**Before the Hearings Panel  
At Waimakariri District Council**

**In the matter of** the Proposed Waimakariri District Plan

**Statement of evidence of Shane Binder (Transport), Christopher Bacon (Servicing, Hazards), Colin Roxburgh (Servicing), Jon Read (Green Space) on behalf of Waimakariri District Council.**

**Date: 16 May 2024**

**ANNEXURE A2 – CRASH ANALYSIS SYSTEM (CAS) OUTPUT**

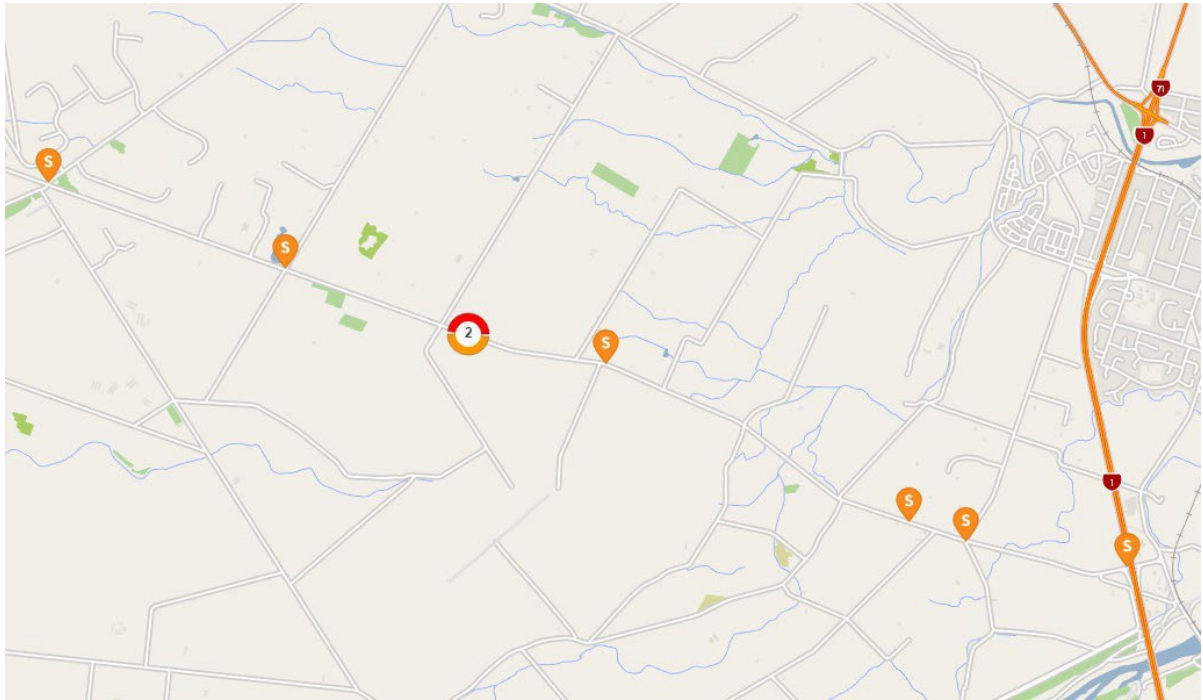
34. Tram Road is considered one of the highest-risk roads in the District, due in part to the long straight stretches without interruptions, higher driver speeds, and relatively higher traffic volumes. The risk of crashes increases through the peri-urban Mandeville area, with a higher frequency of side accesses and turning traffic. It is noted that CAS records between 2018 and 2022 show seven serious injury and one fatality crashes in the segment of Tram Road between McHughes Road / Bradleys Road and the SH1 motorway, as shown in Annexure A2. This crash rate is the highest for the corridor and for any other comparable rural Arterial or Strategic Road in the District.

### **EFFECTS AT TRAM ROAD MOTORWAY INTERCHANGE**

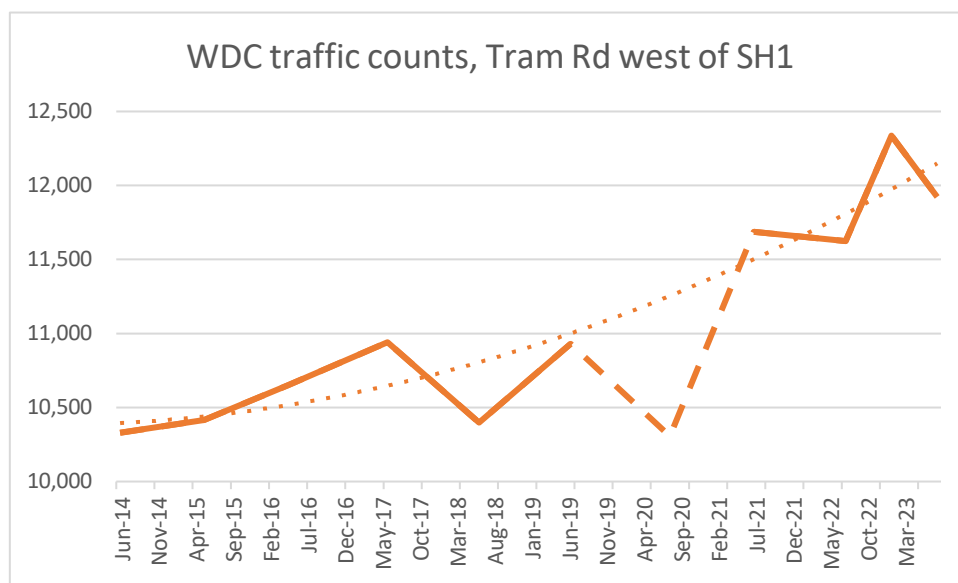
65. In response to comments at the hearing on the Tram Road / SH1 motorway interchange, I have considered Mr Fuller’s modelling and Mr Metherell’s concerns about the assessment.
66. Mr Fuller has considered further growth from future development west of Tram Road in his summary of evidence, based on areas identified in Swannanoa and Oxford<sup>41</sup>. I note that traffic on Tram Rd west of the motorway has been increasing on average at 1.9% per annum
